# CITY OF ALBUQUERQUE

**RE: Family Dollar Store / 4<sup>th</sup> St. NW**  
**Grading Plan and Drainage Report**  
**Stamp Date: 4/6/17**  
**Hydrology File: H14D107**

Based upon the information provided in your submittal received 4/10/2017, the Grading Plan and Drainage Report **is not** approved for Building Permit. The following comments need to be addressed for approval of the above referenced project:

C-100

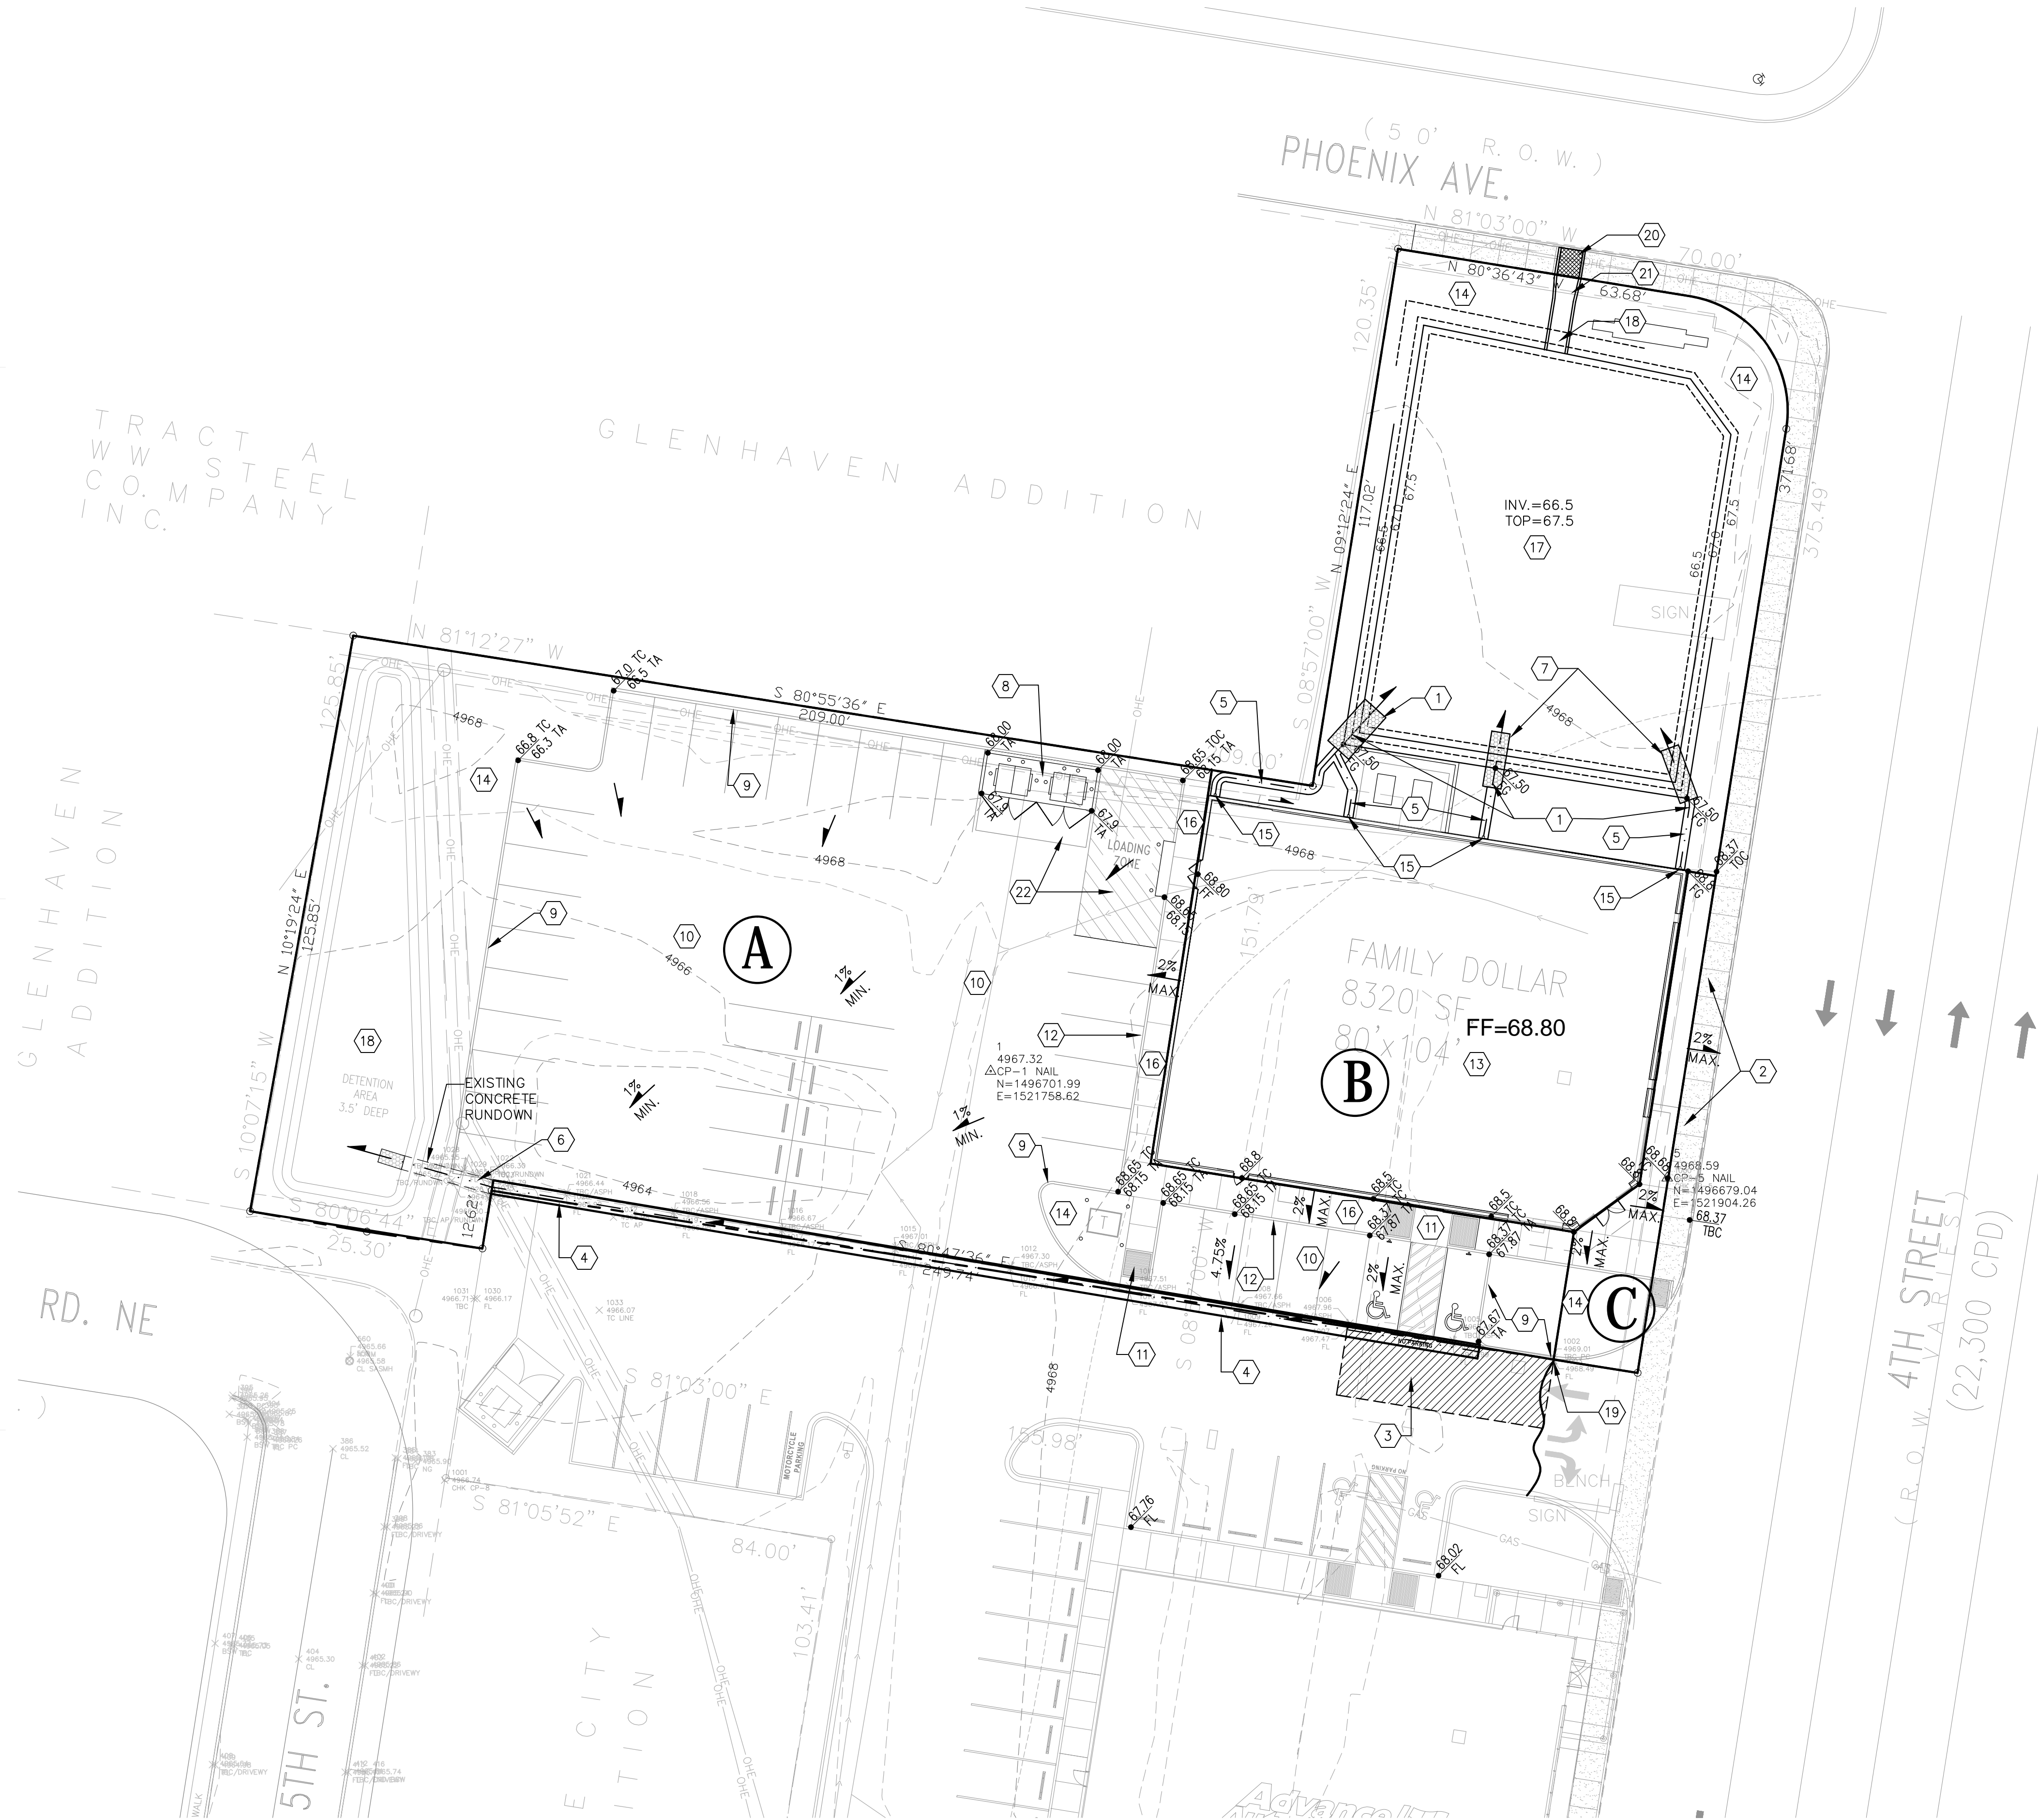
Sheet C-100:

1. Under the existing conditions, it is mentioned that the site is part of an existing master plan. It would have been helpful if you had provided the master drainage plan for information only. That being said, it appears that the proposed water harvest basin 1 on the master drainage plan is bigger and a different shape than what was built as shown on C-101. Please clarify that the volume required and shown in the master drainage plan is being provided for in the as-built basin.
2. Since basin "A" is part of basin "2" of the master drainage plan, it is confusing when trying to compare these two basins since you do not include the existing impervious from the existing adjacent tract in the drainage calculations. Please provide this existing drainage information. A note under the drainage data will suffice.

C-101

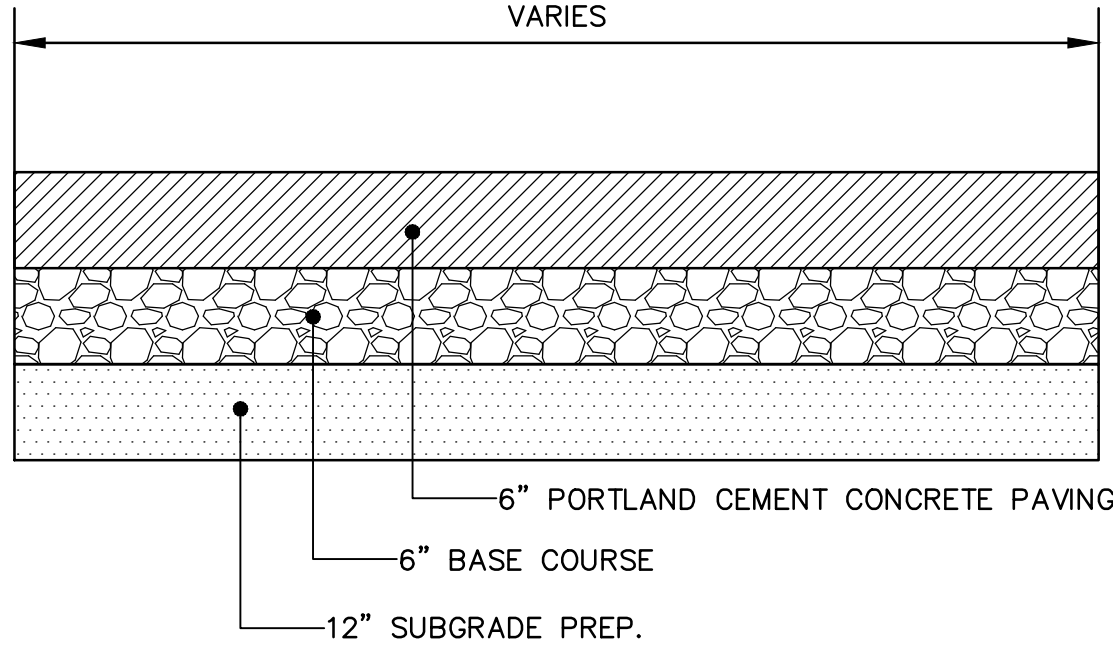
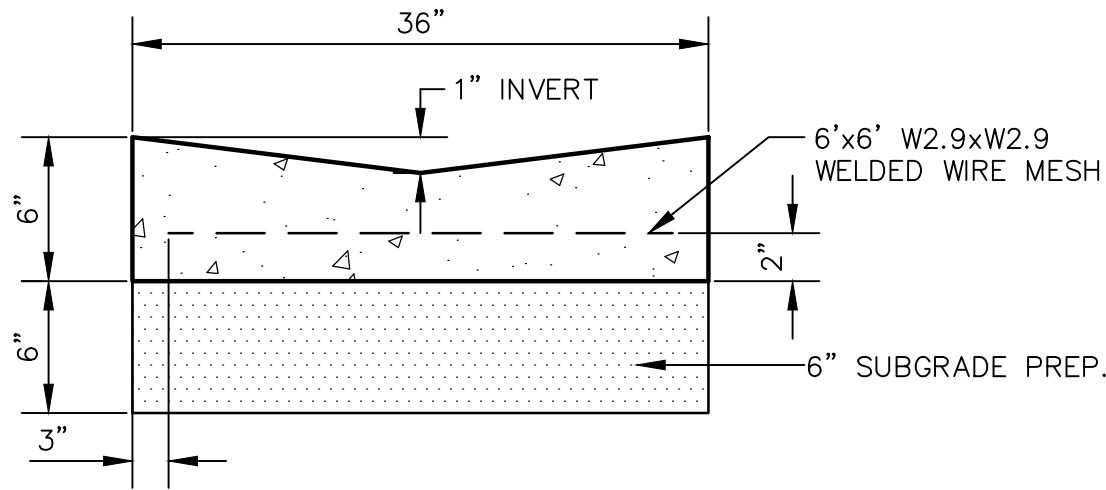
Sheet C-101:

3. Please provide the flowlines for all the proposed concrete channels at both ends (the roof drain and the outfall).
4. Please provide the toe elevations for the proposed rip rap rundown.

5. Under Keyed Notes, #18 the invert elevation is stated as 60.0. However, the existing harvest area has a top elevation is 66.0 and the pond is 3.5 depth, so shouldn't the invert elevation be shown as 62.5 instead of 60.0?

6. Under Keyed Notes, there are two #18s. Please renumber the last five numbers and also change the corresponding numbers on the plan.
7. Please provide the flowline elevation of the start of the proposed valley gutter.

8. Please provide the existing flowline elevation of the existing concrete channel where the proposed valley gutter will connect.
9. Please provide the TC & TA for the corner of the proposed parking near the existing concrete rundown.

10. It appears that the above proposed parking corner is over the existing concrete rundown. If this parking spot is needed, then the existing concrete rundown will have to be replaced or relocated to avoid the construction conflict. Please clarify.

11. Please provide the top and bottom elevation on the shown contours of the existing water harvest basin.
